STATE OF WASHINGTON  
DEPARTMENT OF ECOLOGY

Re: United States Department of Energy Letter, dated July 10, 2007, *Class 1 Modifications to the Hanford Facility Dangerous Waste and Resource Conservation and Recovery Act Permit (Quarter Ending June 30, 2007)*

**Part III, Operating Unit 3, LERF/ETF**

**Hanford Facility RCRA Permit Modification Notification Form**

**Figure 4.4. 200 Area Effluent Treatment Facility**

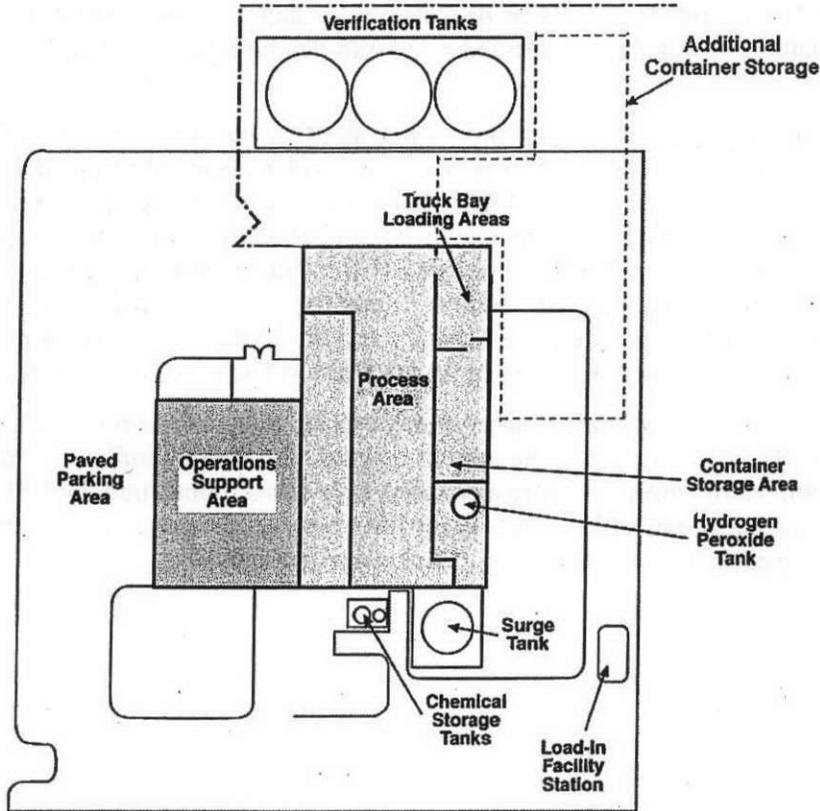
Chapter 4.0, Figure 4.4: added additional container storage area
